# Access Compliance Report

Intersection ID: 16646	Main Street: ORCHARD_CR	Cross Street: S_TRYON_ST	Location: W
ADA ID: E737062E20E9	Ramp Type: PerpDiag	Initial Pass/Fail: Fail	Overall Compliance: No
		Severity Score: 8.75

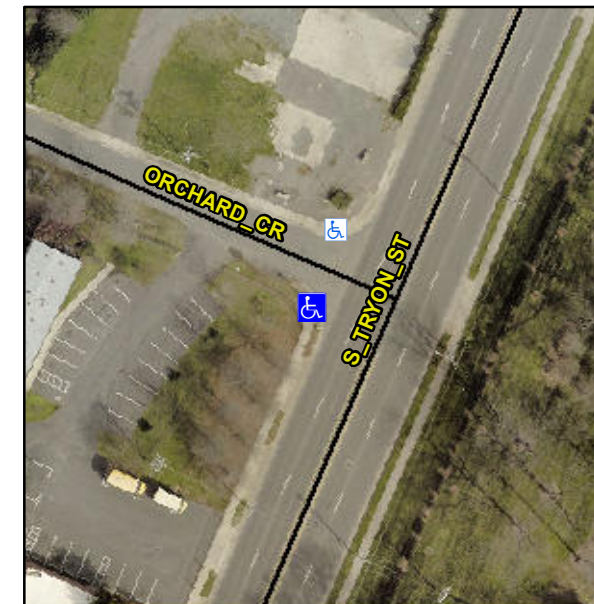
**R304.5.1**

Compliance	Description	Data	Compliance	Description	Data
N/A	Ramp Length (in)	114.0	Yes	Ramp Slope (%)	7.3
No	Ramp Width (in)	38.0	Yes	Ramp XSlope (%)	1.5
N/A	Flare Type LT	N/A	N/A	Flare Type RT	N/A
N/A	Flare Slope LT (%)	N/A	N/A	Flare Slope RT (%)	N/A
N/A	Flare Traversable LT?	N/A	N/A	Flare Traversable RT?	N/A
N/A	Landing Length (in)	N/A	N/A	DWS Provided?	N/A
N/A	Landing Width (in)	N/A	N/A	DWS Contrast?	N/A
N/A	Landing Slope (%)	N/A	N/A	DWS Length (in)	N/A
N/A	Landing X Slope (%)	N/A	N/A	DWS Full Width?	N/A
N/A	Landing Curb? (Y/N)	N/A	N/A	DWS Offset (in)	N/A
N/A	Shared Landing?	N/A			
N/A	Gutter Ponding?	N/A	N/A	Gutter Slope (%)	N/A
N/A	Gutter Lip Ht (in)	1.0	N/A	Gutter X Slope (%)	N/A
N/A	Painted X Walk1?	No	N/A	Painted X Walk2?	No
	X Walk 1 Direction	To SE		X Walk 2 Direction	To NE
N/A	X Walk 1 Width (in)	N/A	N/A	X Walk 2 Width (in)	N/A
	X Walk 1 Slope (%)	0.7		X Walk 2 Slope (%)	1.0
	X Walk 1 X Slope (%)	1.6		X Walk 2 X Slope (%)	1.4

**Remove & Replace Curb Ramp With Two New Directional Ramps or Equivalent.**
